MEMORANDUM DATE: June 28, 2022

RE: **432 South L Street**

TITLE: **HRPB Project Number 22-00100250:** Consideration of a Certificate of Appropriateness (COA) for door replacement for a single family house located at 432 South L Street; PCN# 38-43-44-21-15-157-0010. The subject property is a contributing resource within the Southeast Lucerne Historic District and is located in the Single Family Residential (SFR) zoning district. The future land use designation is Medium Density Residential (MDR).

Exhibit 1 – View of Subject Property

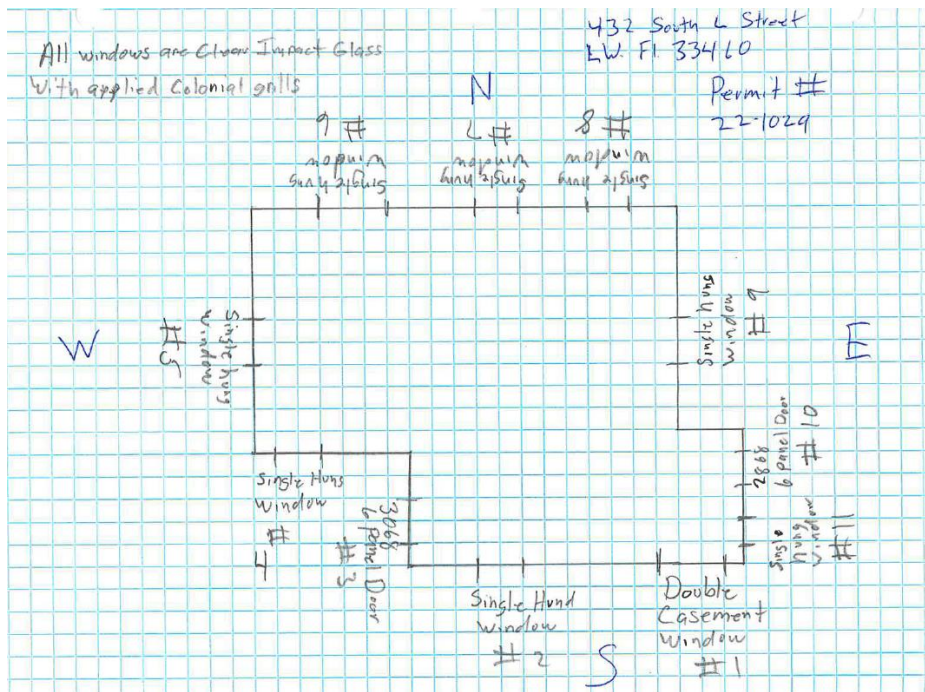
STAFF RECOMMENDATION: Staff recommends that the Board discuss and clarify the use of raised six panel doors versus recessed six panel doors for Wood Frame Vernacular homes. Current Design Guidelines

specify recessed panels. The applicant has interpreted the images of example homes included in the Design Guidelines as raised panels, which is an issue that has been discussed in the past.

Staff Analysis: Based on the City’s Historic Preservation Design Guidelines, staff contends that the proposal is *unsuccessful* in replicating an appropriate door design for a Wood Frame Vernacular structure.

Staff Analysis: Per the regulations set forth in the City’s Historic Preservation Design Guidelines, replacement doors shall replicate their original appearance. The proposed door, according to the Historic Preservation Design Guidelines, is not appropriate to the architectural style.
